Note: Staff reports can be accessed at <https://www.mncppc.org/883/Watch-Meetings>**Detailed Site Plan**
Departure from Design Standards
Alternative Compliance
The Herman Apartments**DSP-22017**
DDS-24003
AC-25009

REQUEST	STAFF RECOMMENDATION
DSP: Development of 145 multifamily dwelling units with associated infrastructure and amenities. DDS: Reduction of the standard, nonparallel parking space size from 9.5 feet by 19 feet to 9 feet by 18 feet, pursuant to Section 27-239.01 of the prior Prince George's County Zoning Ordinance. AC: Alternative compliance from the buffer width requirement of Section 4.6, Buffering Development from Streets, of the 2010 <i>Prince George's County Landscape Manual</i>.	With the conditions recommended herein: • APPROVAL of Detailed Site Plan DSP-22017 • APPROVAL of Departure from Design Standards DDS-24003 • APPROVAL of Alternative Compliance AC-25009 • APPROVAL of Type 2 Tree Conservation Plan TCP2-023-2025 • APPROVAL of a Variance to Section 27-442(c)

SUBJECT: Detailed Site Plan DSP-22017
Departure from Design Standards DDS-24003
Alternative Compliance AC-25009
Type 2 Tree Conservation Plan TCP2-023-2025
Variance to Section 27-442(c)
The Herman Apart

Figure 5: Floodplain acreage comparison with surrounding properties

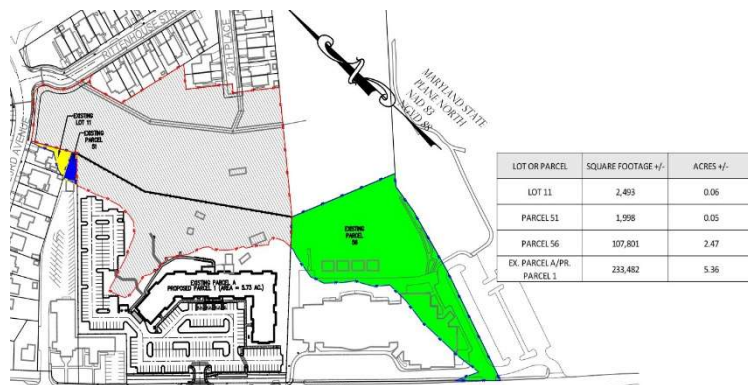
The applicant further provides a graphic showing the area of floodplain on the subject property (outlined in red), compared to the floodplain area on neighboring properties (shown in green, blue, and yellow).

ELEVATIONS

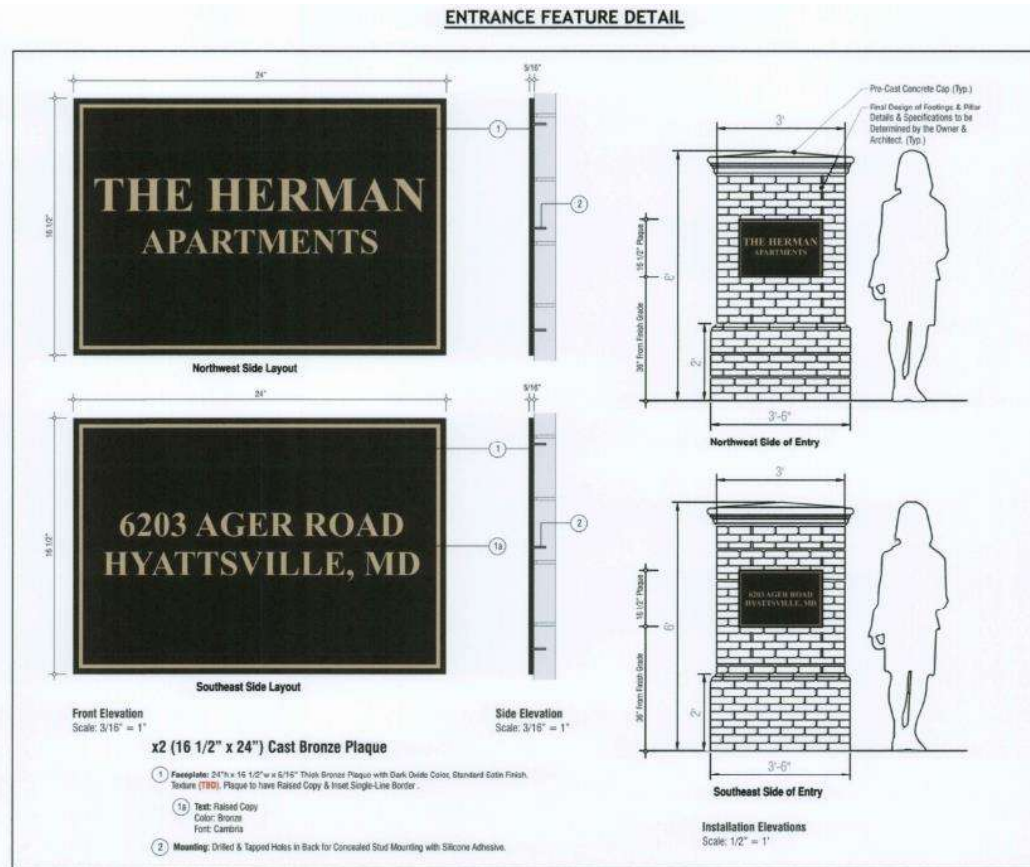
appeal and functionality of the entrance area to provide protection from sun and rain. The building is finished with a mix of materials including faux stone veneer, vinyl clapboard siding, fiber cement paneling, aluminum fascia, and glass. These building materials are proposed across all façades of the building, to ensure a unified and harmonious use of materials and style. Staff find the floor plans and the front elevation F6 A-2.1 are not matching. A condition is included herein requiring the front elevation and floor plan be revised to match.

DEPARTURE FROM DESIGN STANDARDS DDS-24003

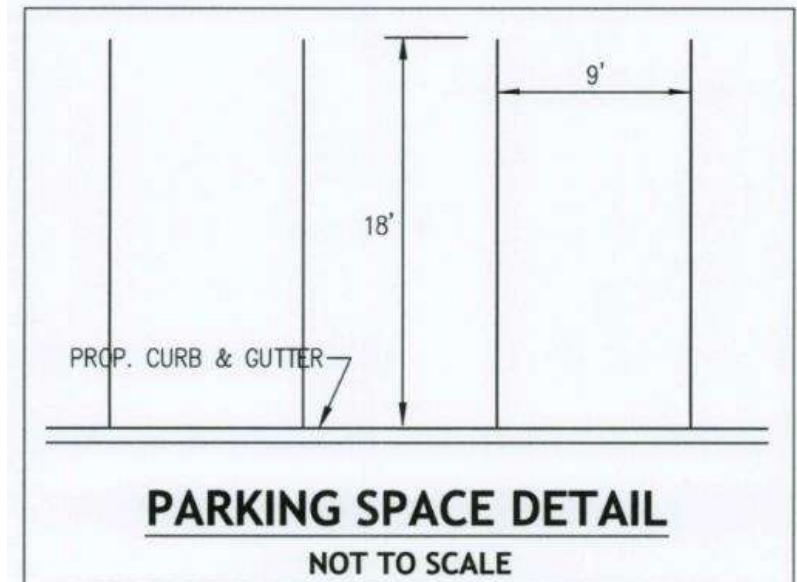
Notes: *Departure from Design Standards DDS-24003 is submitted with this DSP for approval, which is addressed below in Finding 7.d. DDS-24003 seeks a reduction of the required parking space size (9.5 feet by 19 feet) to 9 feet by 18 feet. However, the typical parking space detail still shows a size of 9.5 feet by 19 feet, and the parking departure application number is incorrect. A condition is included herein requiring the applicant to remove the typical parking space detail exhibit, which shows typical parking space size as 9.5 feet by 19 feet, and revise the parking space detail exhibit by showing the correct parking departure application number.
